**SUBJECT:** Sampling and Analysis Plan Addendum for the C-Area Groundwater (CAGW) Operable Unit (OU) (U) (SRNS-RP-2017-00100, Revision 1 Redline, March 2018) and Savannah River Site's Responses to the Regulatory Comments on the Revision 0 Document, CERCLIS Number 82

**SRS Responses to U.S. Environmental Protection Agency Comments on: Sampling and Analysis Plan Addendum for the C-Area Groundwater (CAGW) Operable Unit (OU) (U), CERCLIS Number: 82, SRNS-RP-2017-00100, Revision 0, dated April 2017, Savannah River Site, Aiken, South Carolina.**

**SRS Responses to South Carolina Department of Health and Environmental Control Comments on: Sampling and Analysis  
Plan Addendum for the C-Area Groundwater (CAGW) Operable Unit (OU) (U), CERCLIS Number: 82  
(SRNS-RP-2017-00100, Revision 0, April 2017) received May 15, 2017.**

Figure 11. CAGW OU TCE Plume (2016)

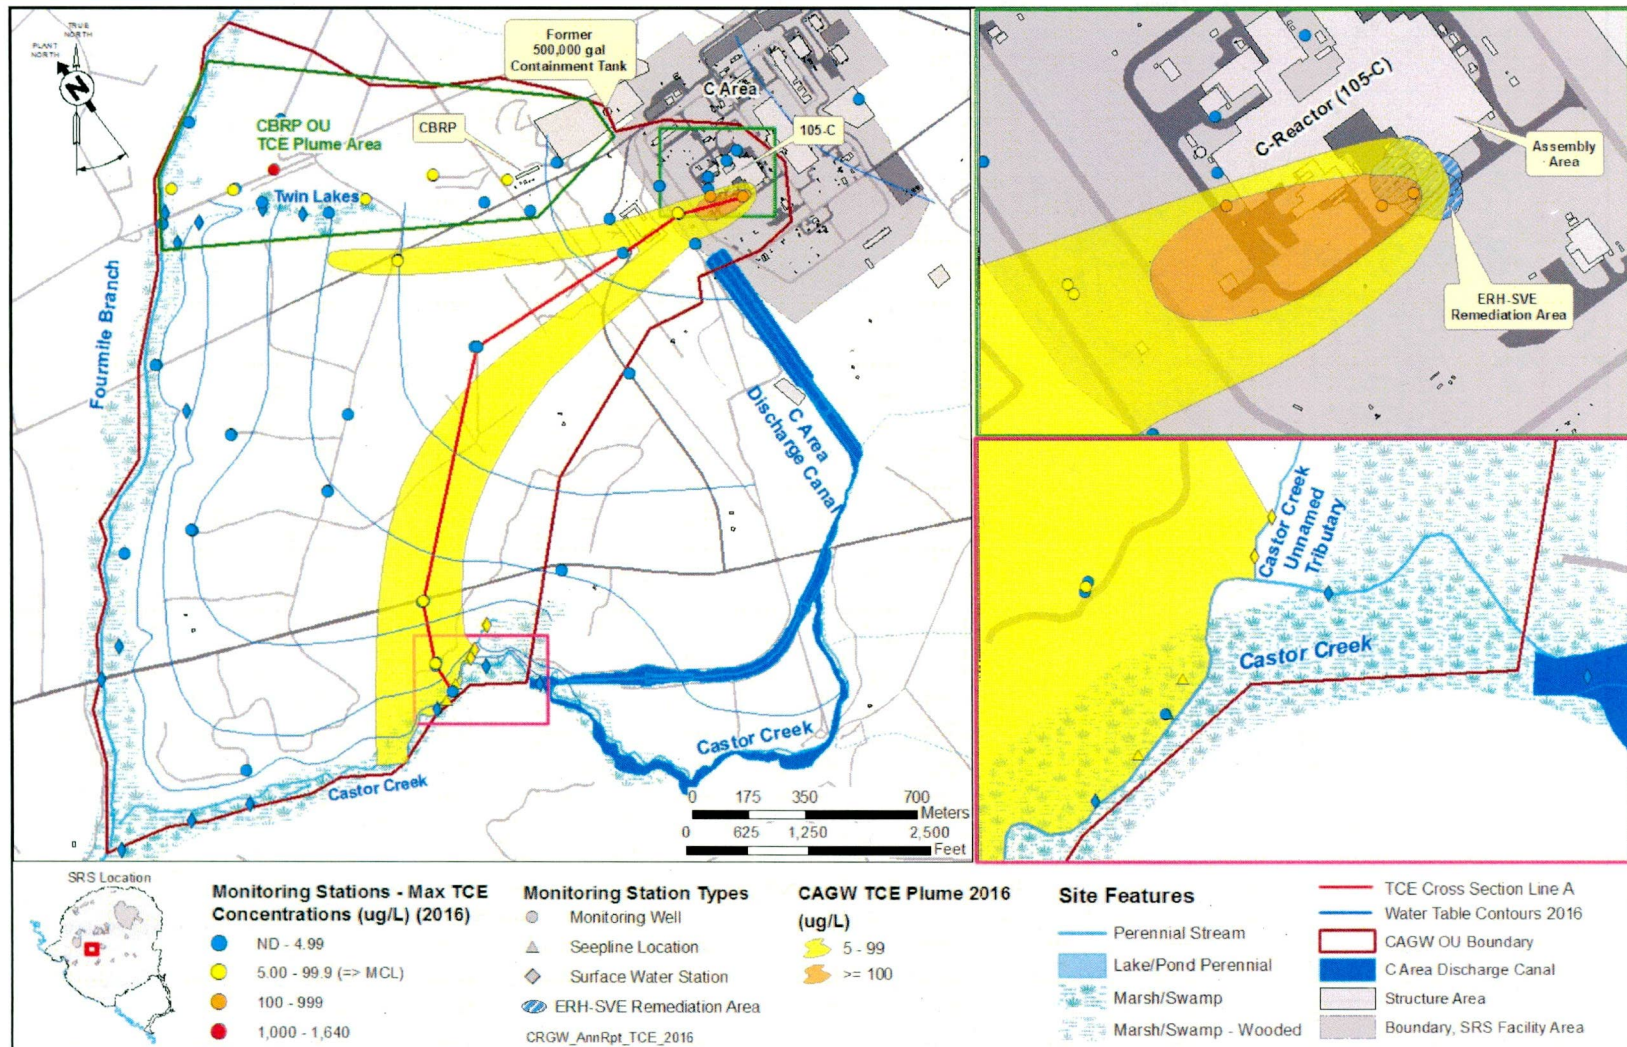
2. Figure 11, CAGW OU TCE Plume (2016), page 35. The top-right insert on this figure which depicts the ERH-SVE Remediation Area is shaded in red, which can be confused with groundwater locations at which TCE concentrations were greater than 1,000 µg/L in 2016. Please depict this area using a different color or method to avoid confusion.

**Response: Agree.**

**Figure 11 will be revised to show the ERH-SVE Remediation Area in a different color/pattern (see attached figure).**

**Figure 20. Phase 2 Castor Creek Proposed DPT Groundwater Samples and Wells**

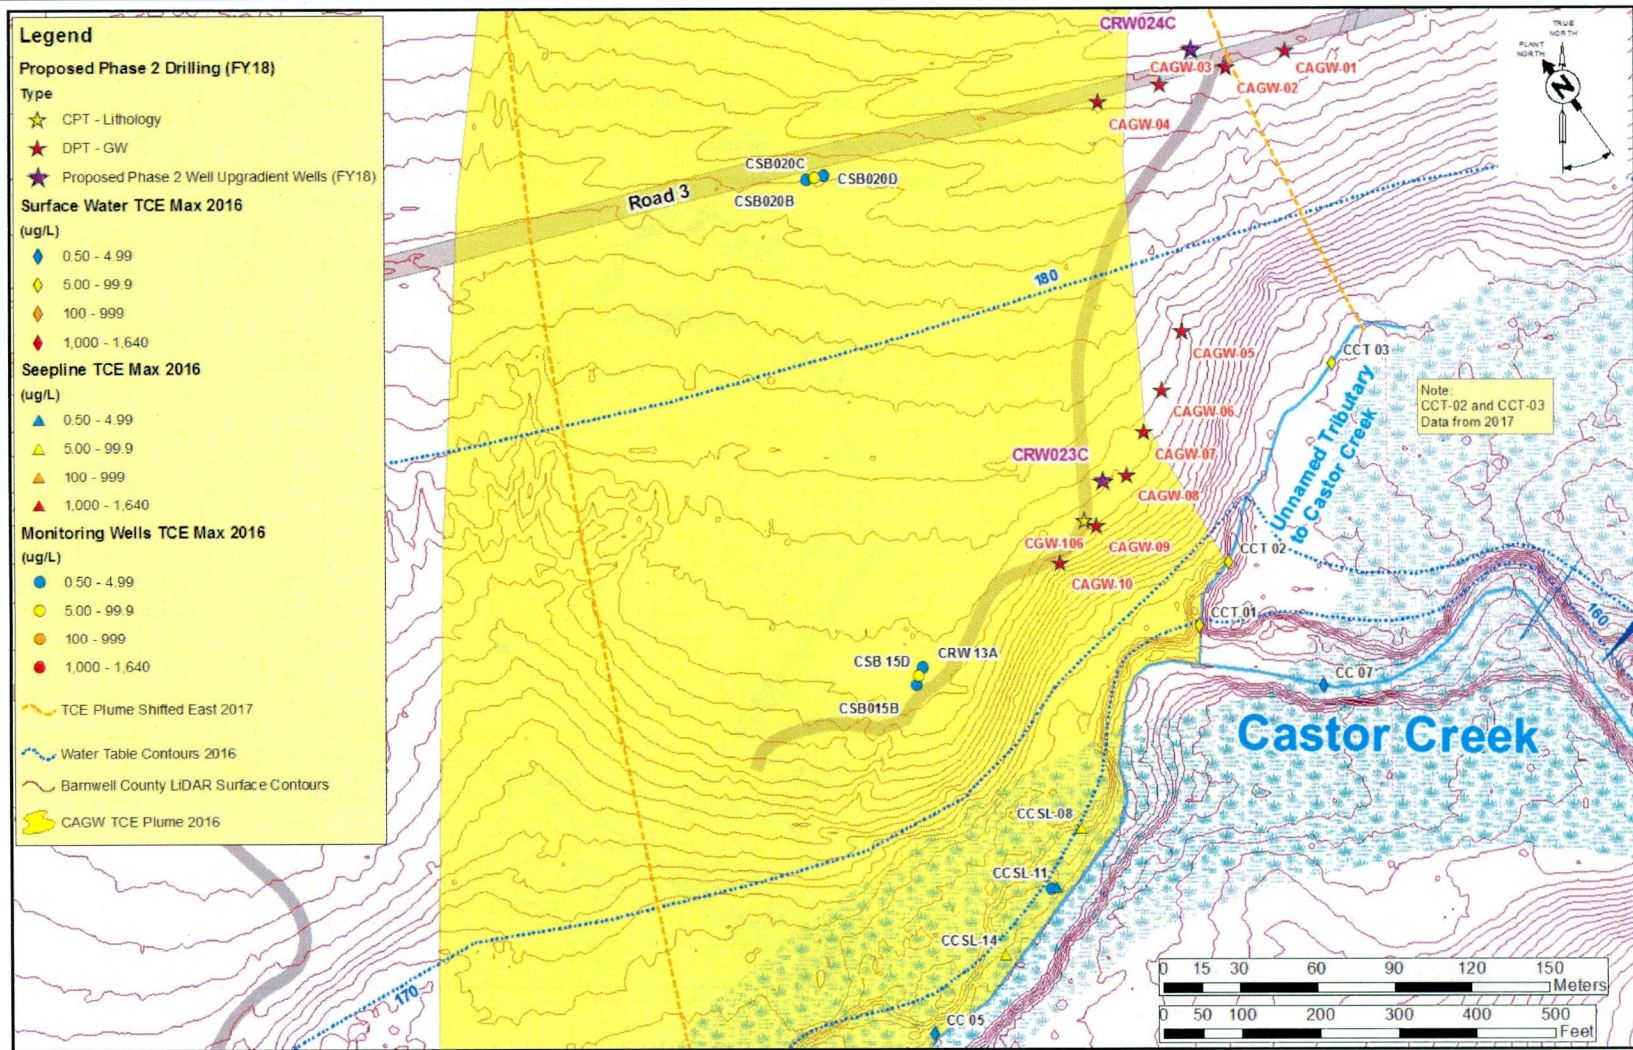
4. Figure 20 (Phase 2 Castor Creek Proposed DPT Groundwater Samples and Wells) presents tritium and TCE concentration results from 2011 and 2012, but does not include 2016 data. For clarity figure 20 should be revised to address this issue.

- 
3. Figure 20, Phase 2 Castor Creek Proposed DPT Groundwater Samples and Wells, page 45. Please label Road 3 on this figure, as referred to on page 9 of Section 3.2.

**Response: Agree.**

Figure 20 will be revised to show 2016 data and some limited 2017 data (see attached figure).

**Response: Agree.**

**Figure 20 will be revised to show Road 3 (see attached figure).**
